TECHNICAL SERVICE BULLETIN

TSB #:	TSB40082301	Release Date:	9/12/2023
Main Group:	40 - Interior		
Subject:	Instrument Panel (IP) Vents – Malfunction and Replacement		
Vehicle:	FM29 OCEAN	Production Range:	SORP
Model Year(s):	2023	Region(s):	Global
Mobile Service:	NO

Figure 2. Air vent with hot melt rework

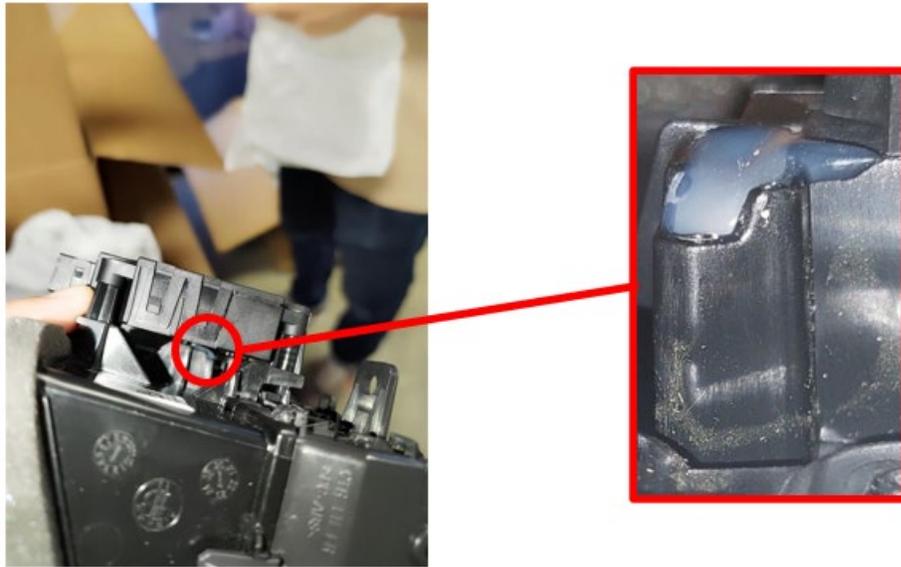
1. FM29 DEV SP 0442 AIR VENT: Identify an extra white hot melt component on the end stop area.

Figure 3. Air vent with 3D insert

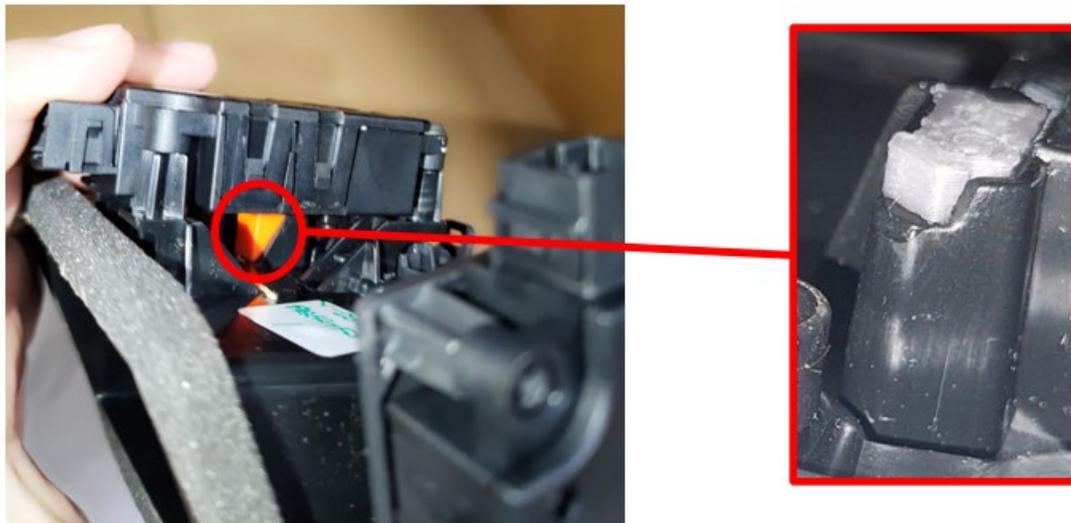
2. FM29_DEV_SP_0451 AIR VENT: Identify a 3D printed insert on the end stop area can be orange, red or white color.
